Castle Wind Energy Facility and associated infrastructure, Northern Cape Province

Motivation for amendment of Environmental Authorisation

DEA Ref.: 14/12/16/3/3/2/278

September 2019

Figure 5.1.1: The position of known Verreux's Eagle nests & 3km buffers relative to the proposed site. **(A3 Map included in Appendix F).²**

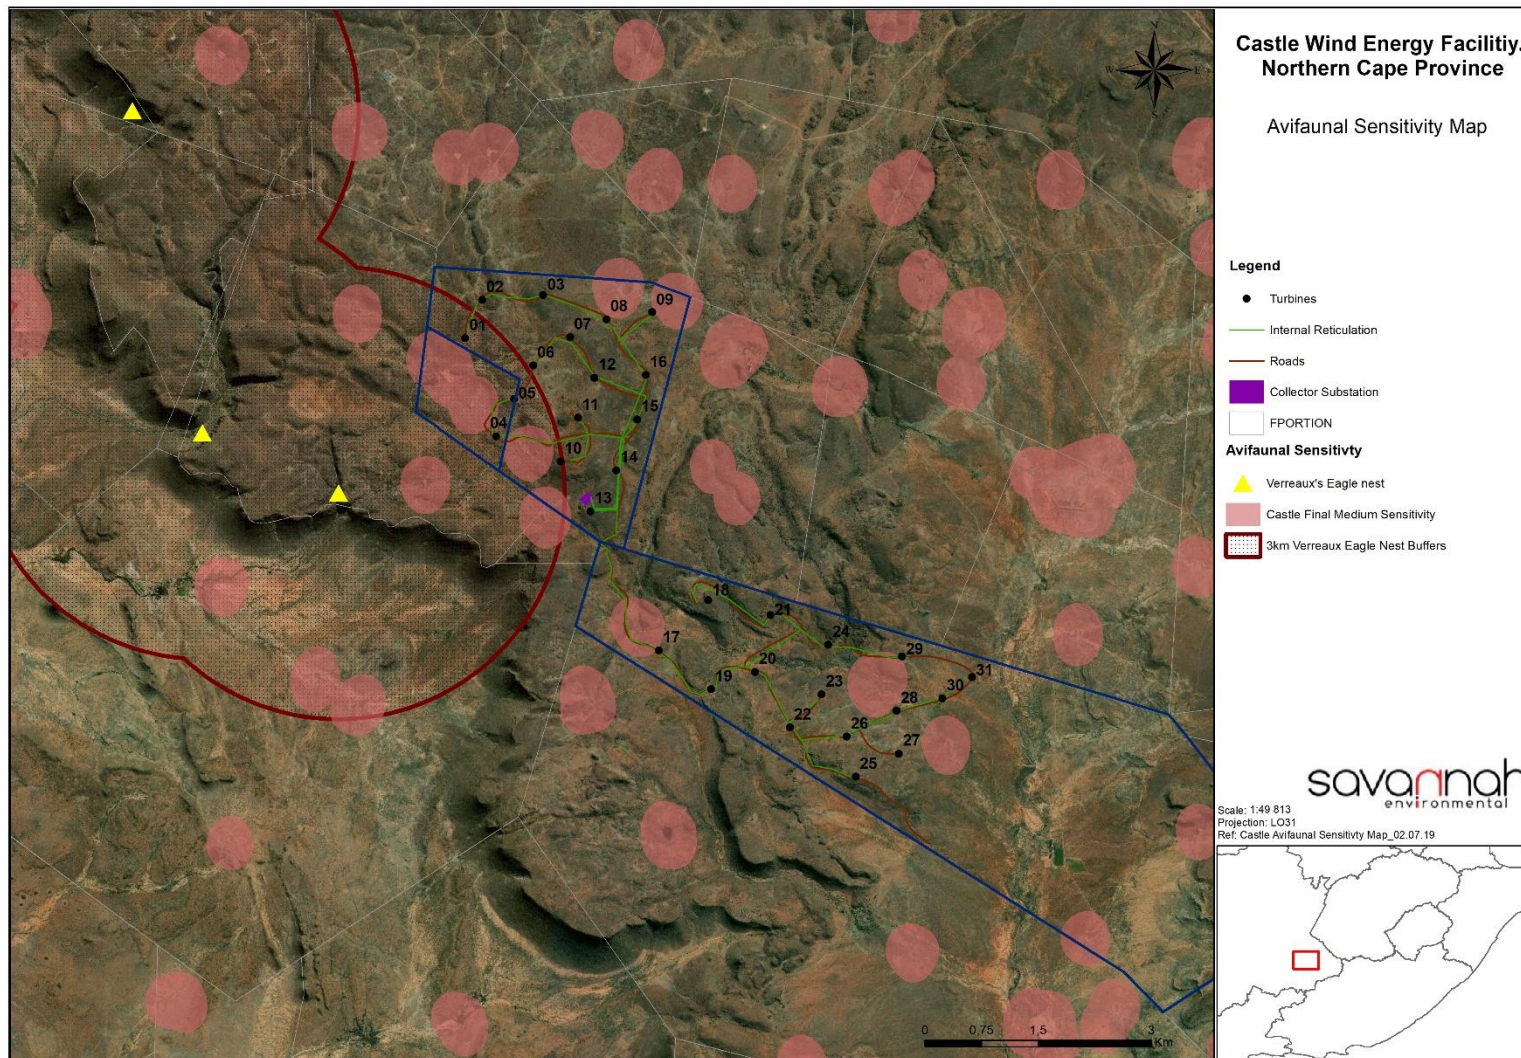
Verreaux's Eagles have been recorded at the Castle WEF project site and three known Verreaux's Eagle nests were identified during the pre-construction monitoring. The closest of these nests is relevant since it is approximately 2.2km from the nearest turbine. During a site visit conducted by the specialist from 9 to 11 September 2019 the two closest eagle nests to the Castle site (Slingshoek Waterval at 24.26551, -30.59601; & Slingshoek at 24.24571, -30.58687) were visited and the Slingshoek Waterval nest was found to be active and the territory is occupied by a pair of adult eagles. It was assumed that the nest was used for breeding this past season but could find no sign of a chick or juvenile. The pair of adult eagles was seen in the territory on two consecutive days, sometimes perched on the nearby Eskom pylons. At the Slingshoek nest the specialist found no sign of use or breeding activity in recent years and concluded that the nest has been abandoned, or was possibly an alternate nest for the Slingshoek Waterval pair of eagles (it is only 2.4km between these two nests). In addition to the main nest, a second possible alternate eagle nest approximately 50m away was found, as was a presumed Hamerkop nest approximately 200m away. The nest at Pienaarskloof (at 24.23537, -30.54760) has been abandoned (Van Rooyen, 2019). We also surveyed all potential nesting substrate within these areas.

The Verreaux's Eagle nests are indicated relative to the Castle Wind Farm in Figure 5.1.1. A 3km no-go buffer around the nests was implemented in the layout and three turbines currently fall within this buffer. In order to adhere to the buffer, the removal/relocation of the three turbines (Turbines 1, 4 and 5) during final design and micro-siting is recommended by the specialist. If infrastructure is constructed within this 3km buffer area, it would necessitate further survey work on site.

» ² Turbines 1, 4 and 5 will need to be relocated/removed during final design and micro-siting in order to adhere to the 3km buffer.

Figure 5.2.1: Due to the updated guidelines, a number of turbines are now located in High Bat Sensitivity areas. These turbines will need to be relocated during micro-siting or removed from the layout (**A3 Map included in Appendix F**).

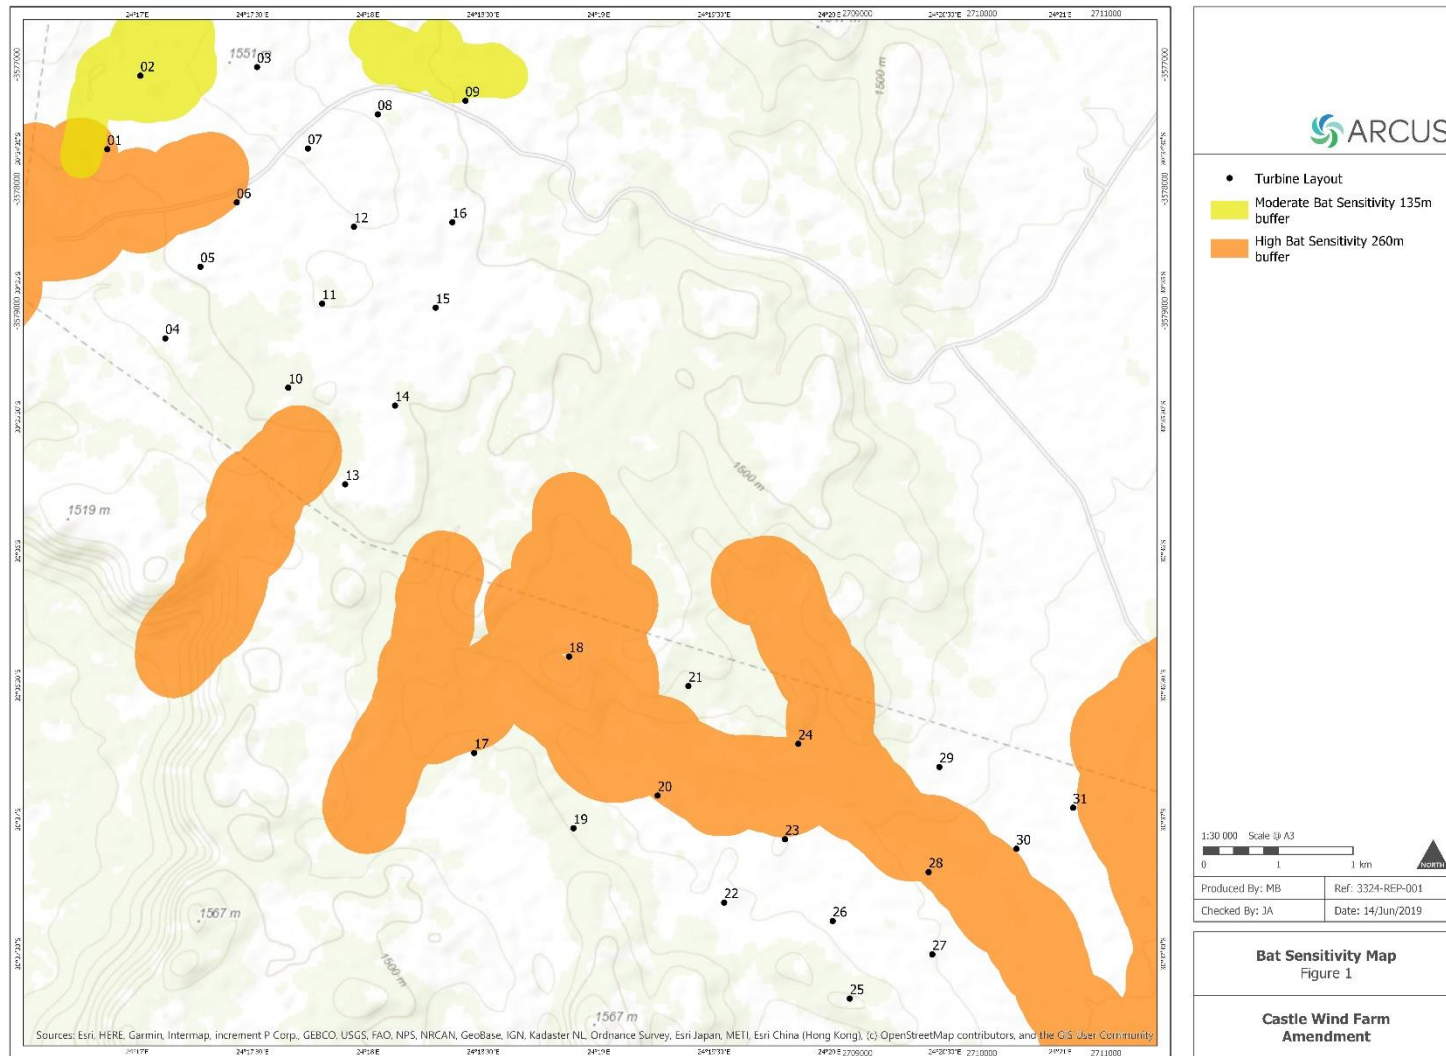
Using the formula above, the 150 m high sensitivity buffer would need to be either 184 m or 200 m to blade tip. The 100 m moderate sensitivity buffer would need to be either 126 m or 132 m to blade tip. Based on this, some turbines are now located in bat sensitive buffers (Table 5.2.1). The guidelines applicable during the initial Bat Impact Assessment (Animalia, 2014) stipulated a buffer of either 100 m or 150 m (Sowler and Stoffberg, 2012). Subsequent to the initial Bat Impact Assessment revised guidelines have been released (Sowler et al. 2017). These guidelines recommend a minimum buffer of 200 m to blade tip for important bat

features. The specialist recommended that based on the bat activity at the site, the moderate sensitivity buffer should be sufficient at 100 m. The increase in the high sensitivity buffer from 150 m to 200 m results in some turbines being located in buffer zones (Table 5.2.1 and Figure 5.2.1). These turbines will need to be relocated from the layout during final design and micro-siting.

The proposed amendment is unlikely to alter (increase or decrease) the impact significance as assessed during the EIA process. These impacts would remain the same assuming the mitigation measures proposed in the pre-construction bat monitoring report and EMPr are adhered to. The mitigation measures included the implementation of operational bat monitoring and assessing the need for curtailment and the avoidance of sensitive areas for bats by adhering to the sensitivity map (Figure 5.2.1). No additional mitigation measures are required.

Figure 5.3: Viewshed analysis represents the potential total visual exposure of the original turbine dimensions (illustrated in green) compared to the proposed new turbine dimensions (illustrated in red).

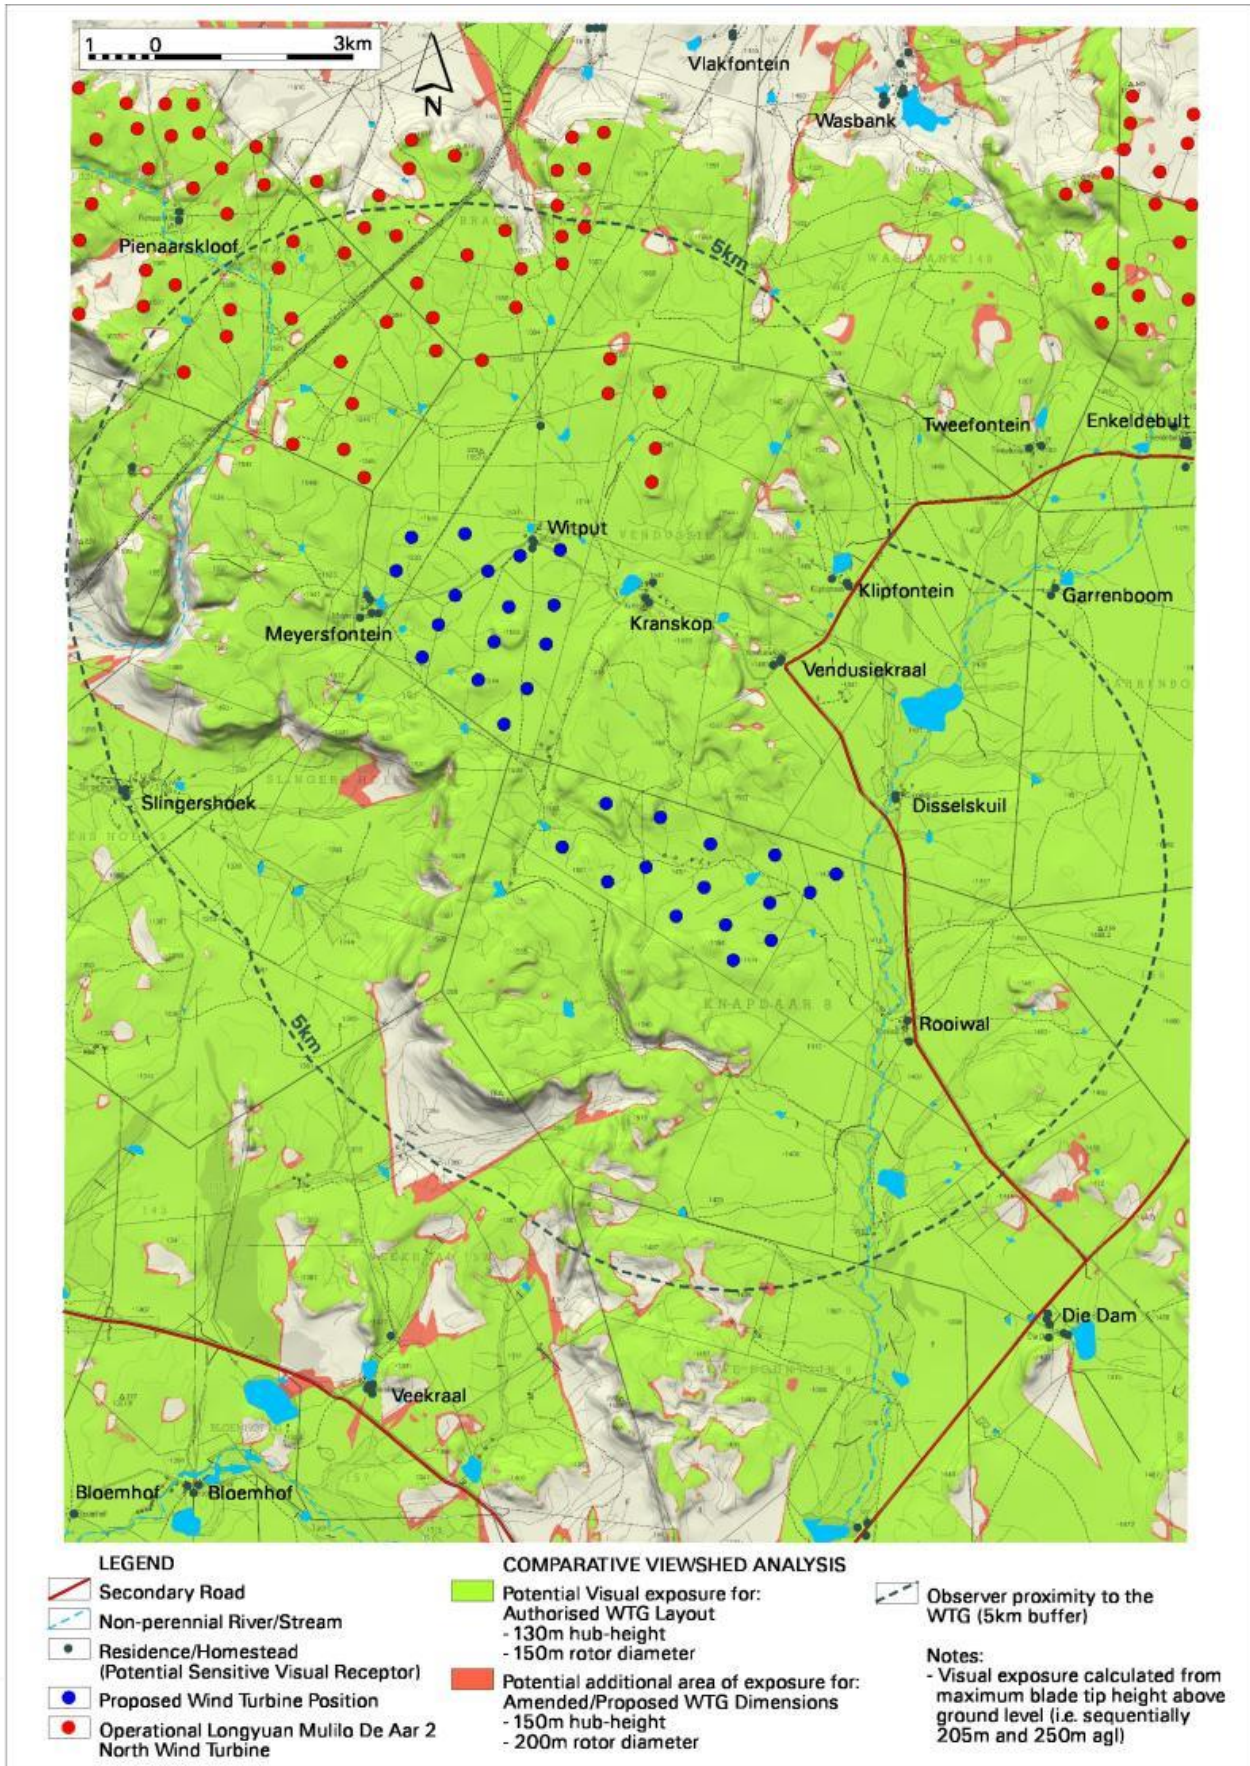
The visibility analysis was undertaken from each of the wind turbine positions (31 in total) at an offset of 205m (maximum blade tip height) was used. This result indicates the total visual exposure from the Visual Impact

Assessment during the EIA process (indicated in green). The 250m maximum blade tip height was used as input and the visual exposure is shown in red. The results of the visibility analyses are displayed on **Figure 5.3** below. The visual exposure increased by 18% and the specialist concluded that this would have a relatively small influence on the overall visual exposure. The surface area exposure increased from **325km²** to **336km²** with the increased dimensions in the proposed amendment. This constitutes a **3%** increase in potential visual exposure which was also concluded to be of low significance.

It is expected that the wind turbine structures, both the original dimensions and the proposed increased dimensions would be equally visible and noticeable from both the roads and homesteads identified above, therefore signifying a negligible change to the potential visual impact.

Figure 9.1: Wind farm layout with updated specialist environmental sensitivities (A3 Map included in **Appendix F**)³

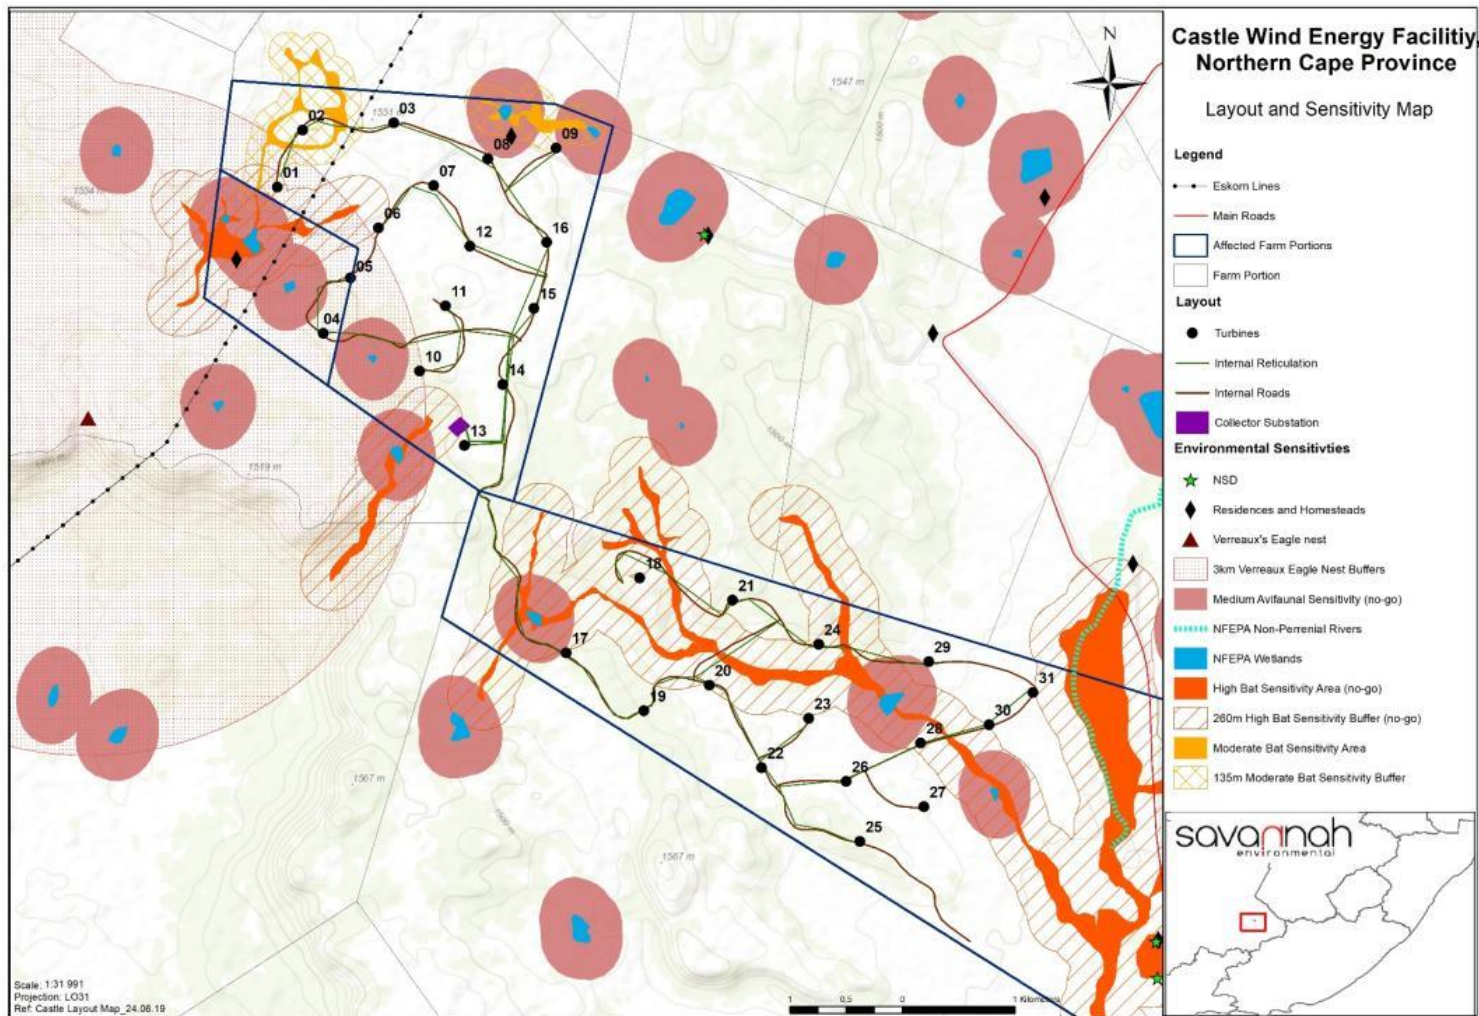
³ No Additional sensitivities were identified during the current amendment process. The Verreaux's Eagle buffer was added during the amendment process due to new guidelines that came into effect and the bat sensitivity buffer was increased in order to be in line with current guidelines.
